CITY OF NEW BEDFORD
SEWER AND/OR STORM DRAIN PERMIT

BUILDING PERMIT

RE: TB-21-2840
Rivet St. (N.S.) 44' E. x Acushnet Ave. (f/k/a 93-101 Rivet St.—M! Antjo Rest. & Apts.)
Plot 31/Lot 111
Reviewed 11/12/2021

The site plan (dated 9/17/2021) submitted via View Permit was reviewed by DPI. This permit is denied, pending addressing the following comments:

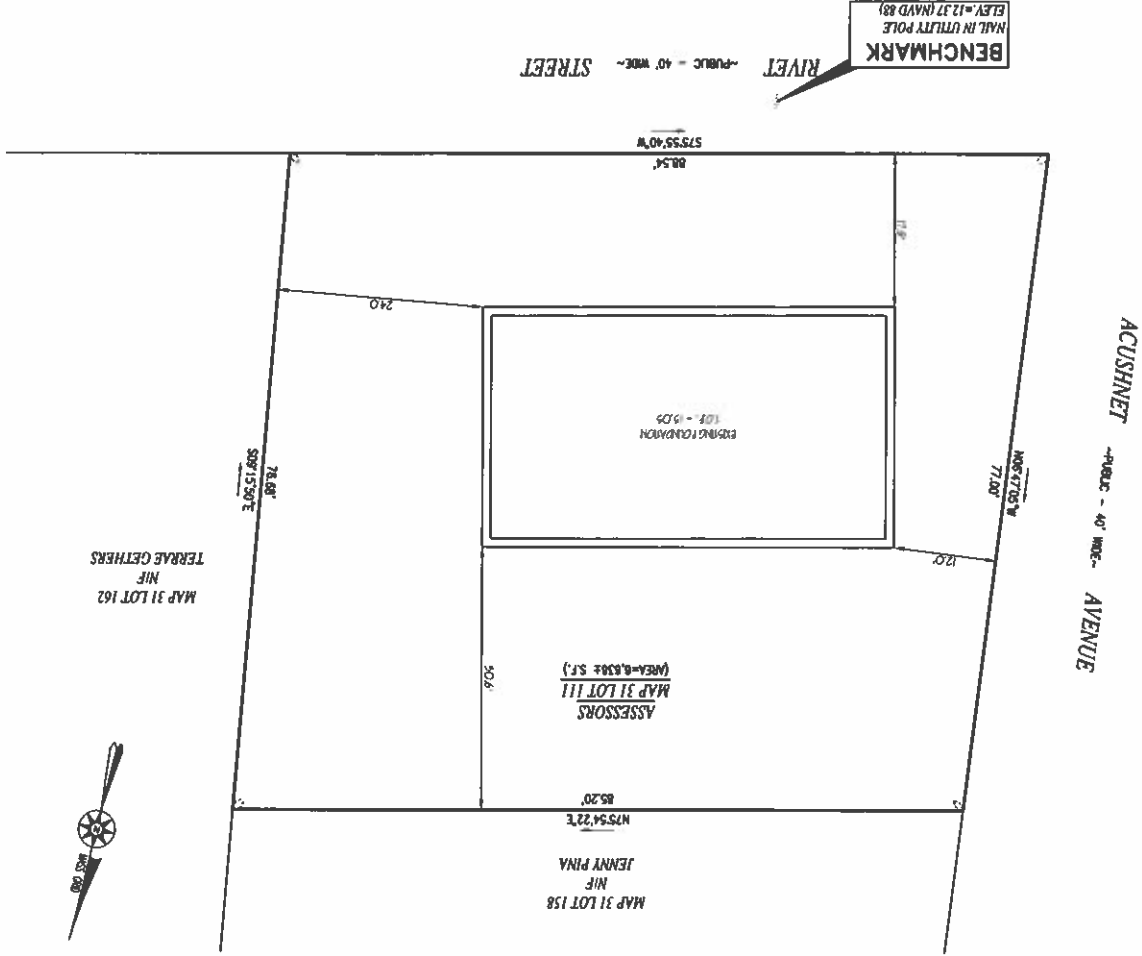
1. Update the "Record Owner" and the "Prepared For" info. to reflect the correct address for the property owner, as the property owner is not at the address stated (structure known as 93-101 Rivet was demolished due to fire).

2. Remove "97 Rivet St." from plan title. This is vacant land, describe as such. If you need to make reference to the address of the former structure, please denote as "f/k/a".

3. Trim southerly lot line to terminate at intersection with westerly lot line.
4. Add label "Full-Width Cement Concrete Sidewalks" to existing sidewalks along Acushnet Ave. and Rivet St.

5. Show existing retaining wall along property line/back of sidewalk. If it is to be removed, label as such, and add note that "Sidewalk Squares Damaged/Undermined as Result of Wall Removal are to be Replaced".

6. Add note that "All existing cement concrete sidewalk squares that are broken/damaged along both the Acushnet Ave. and Rivet St. side are to be replaced".

7. Add note that sidewalk squares/panels adjacent to the curb are to be sawcut along joints and grass ribbon installed along Acushnet Ave. and Rivet St. Based on the measures obtained during DPI's site visit, the grass ribbon along Acushnet Ave. would be 3', the grass ribbon along Rivet St. would be 3'-7". Please contact DPI for more information regarding this matter.

8. Driveway opening along Acushnet Ave. side to be closed. Add label denoting length of curbing to be installed. Add call out to "Install GVC and Match Abutting Proposed Grass Ribbon/Cement Concrete Sidewalks".

9. Label the new 14' cement concrete driveway, which appears is being proposed in the same location as the existing. Add call out that the existing driveway on the Rivet St. side is to be replaced, as it is in dire shape. Also, due to the 2" curb reveal noted during DPI's site visit, the requirement for transition curb/wing areas for the proposed cement concrete driveway opening is waived for this application. Adjust the location/elevation of the highpoints shown on the plan view to be at the property line. Water from the City layout is not to run onto the private property, and vice versa.

10. Traffic flow on Rivet St. tends to be heavy at times. For safety reasons and providing ease of access, the applicant should re-evaluate the proposed 14' driveway opening on Rivet St. and consider widening it. Residential driveways can be a maximum of 18'.

11. Label size/type of all existing water and sewer services and which are being reutilized/abandoned.
12. Add note that the sewer service on Acushnet Ave. not being reutilized is to be properly abandoned (cut/cap at property line) and witnessed by DPI personnel. (Note: There is no record of a demolition permit sign off from this department, nor respective inspection records denoting that DPI personnel witnessed existing water/sewer services were properly abandoned prior to the building being demolished.)

13. Show proposed water service from the new dwelling all the way to the existing curb stop (no couplings allowed). Keep line types consistent, and show proposed in bold and existing in grayscale. Call out that the condition of that portion of existing water service

on Rivet St. that is to be reutilized is to be determined prior to connection. (See "Note" in item 12).

14. Location of existing sewer service on Rivet St. is shown incorrectly (Please refer to DPI sewer/storm drain map or sewer service record). Call out that the condition of that portion of existing sewer service on Rivet St. that is to be reutilized is to be determined prior to connection. (See "Note" in item 12).

15. Label size/type of all existing mains.

16. The size of the existing sewer main on Acushnet Ave. is labeled incorrectly (It is 15").

17. Properly depict existing Bradley head catch basin.

18. Label the size/type of piping being specified by the engineer for the infiltration system on the plan view. Also, please show the point of entry of the proposed subsurface roof recharge unit located at the southeast corner of the parcel into the house (it appears to have been left "floating").
